ADDENDUM NO. 1

**Military Vehicle Compound, Fencing and Site Improvements
Jefferson Barracks
74 Kearney St.
St. Louis, Missouri
PROJECT NO.: T2504-01**

Bidders are hereby informed that the construction Plans and/or Specifications are modified as follows:

C-103R

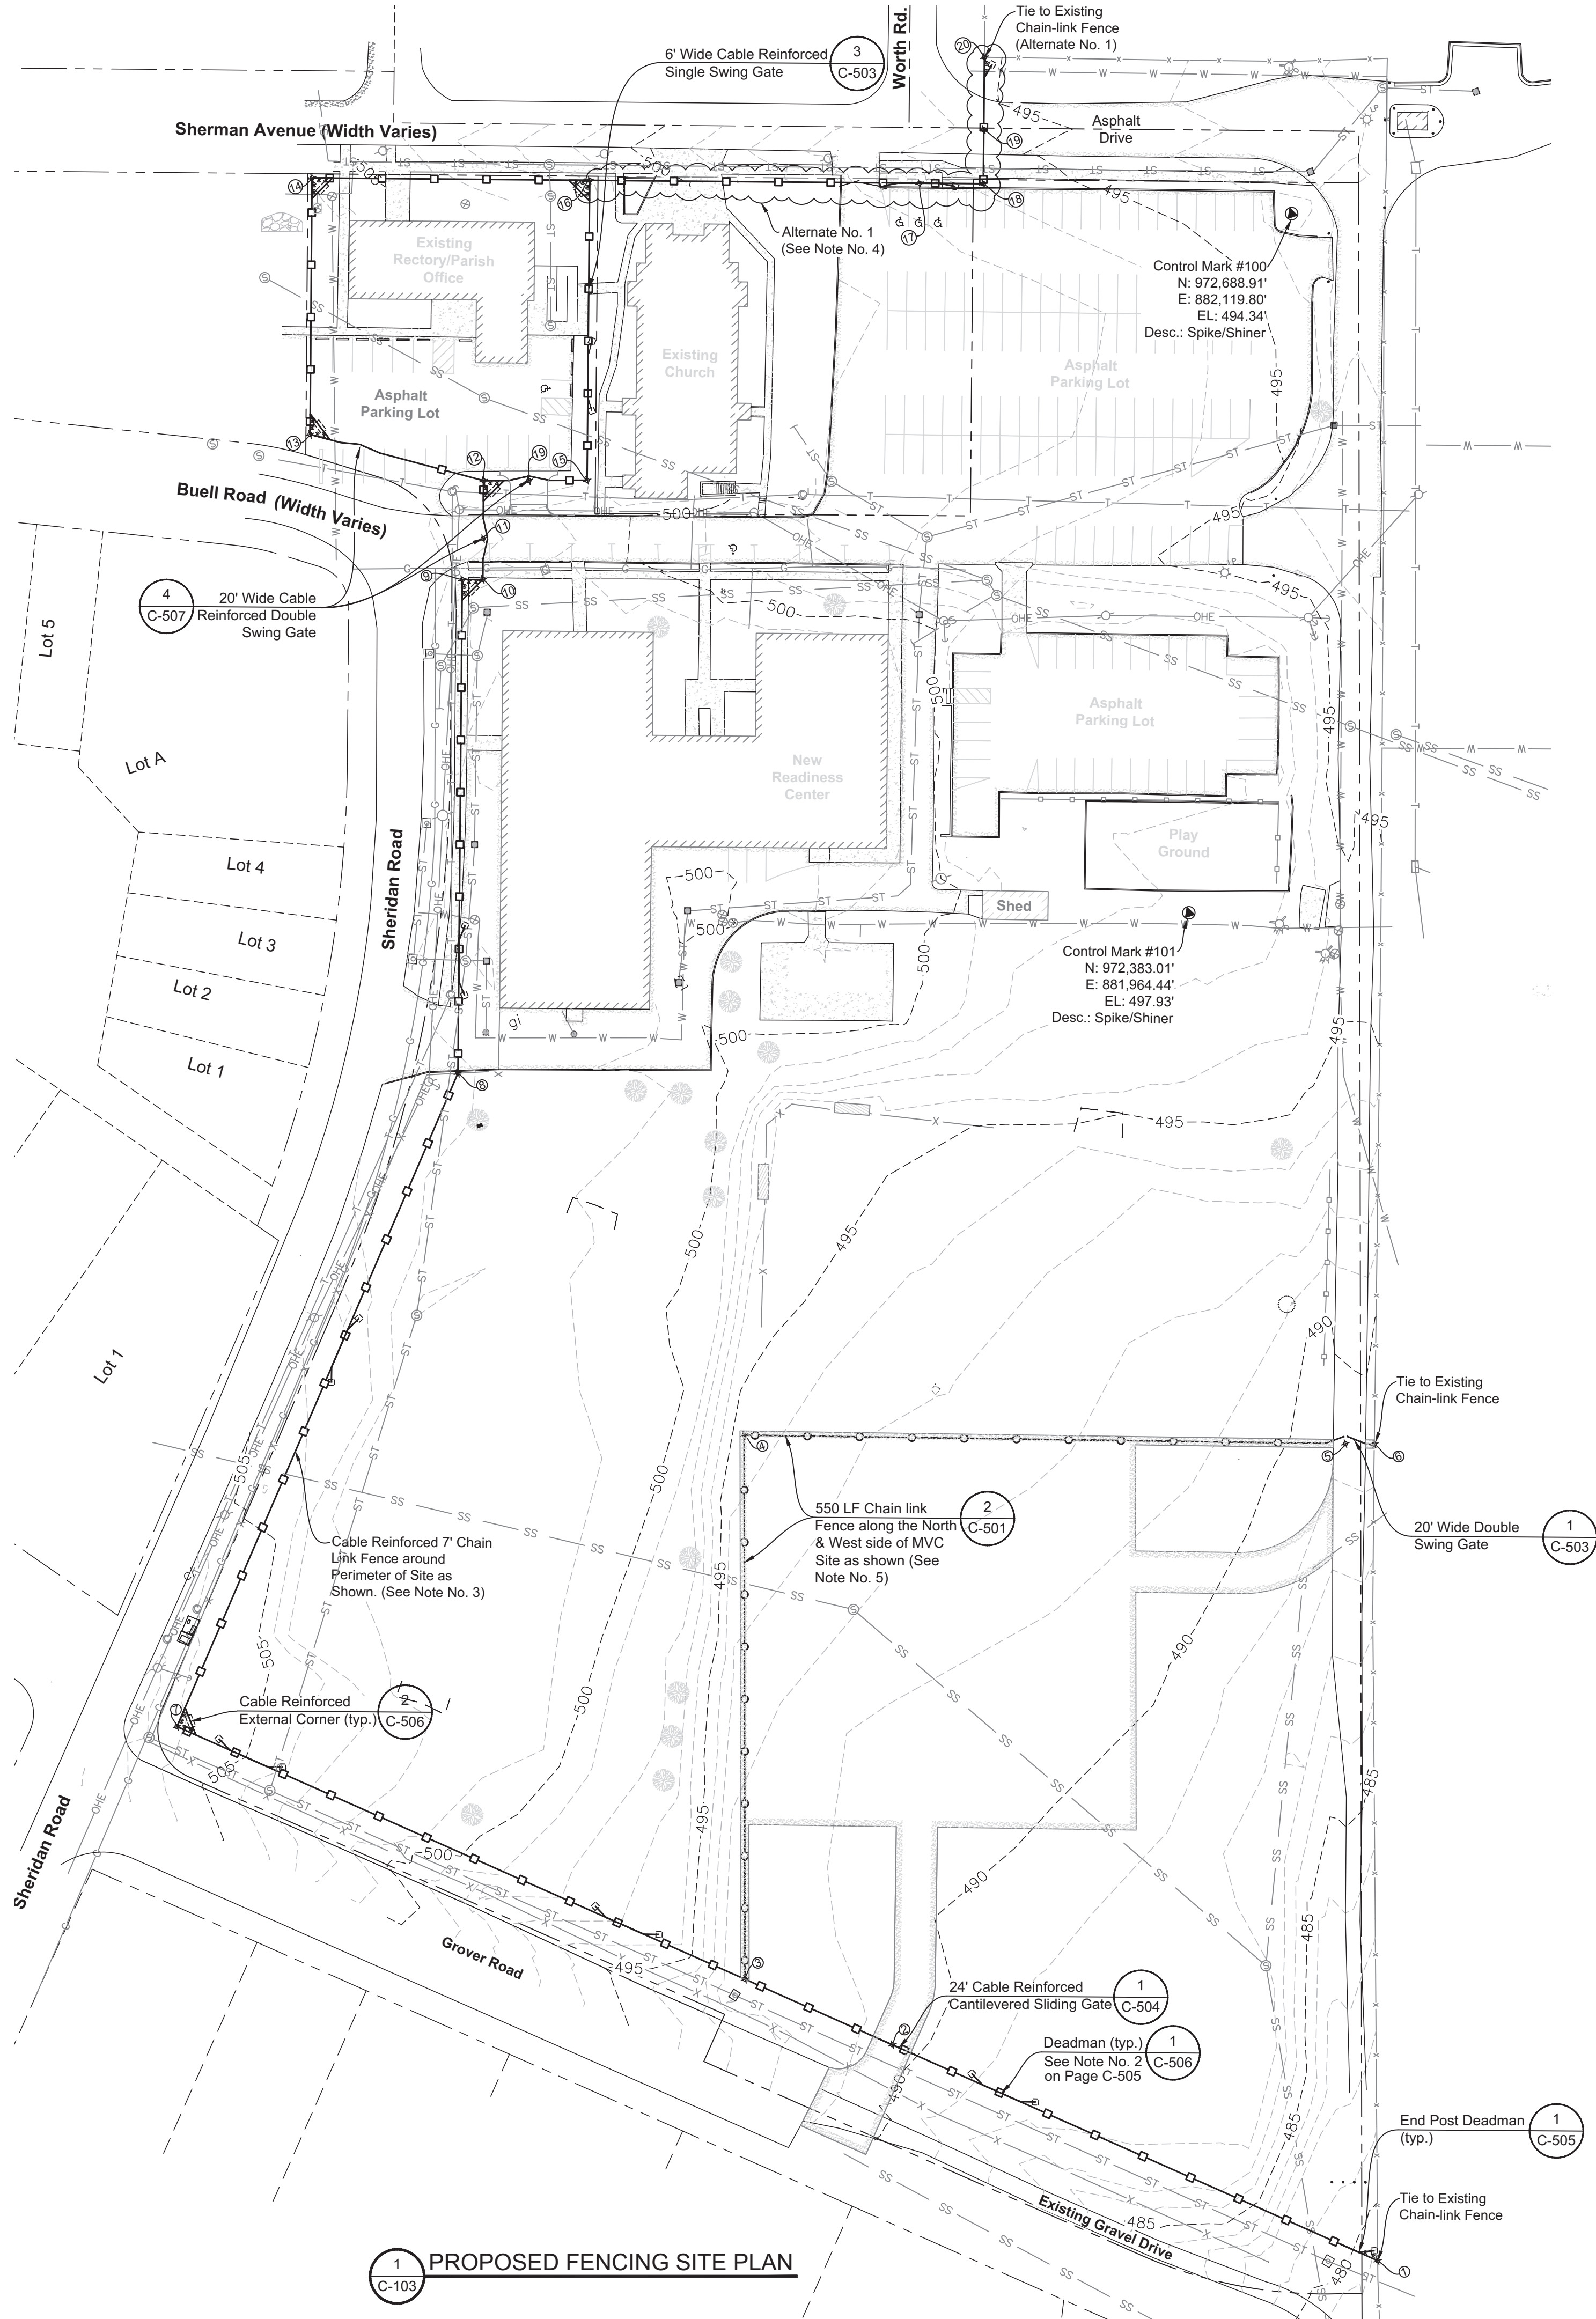
- 1. REMOVE:**
Sheet C-102 (BMP Drainage Area Map)
- 2. REPLACE:**
Sheet C-103 with C-103R
Sheet C-104 with C-104R
Sheet C-105 with C-105R
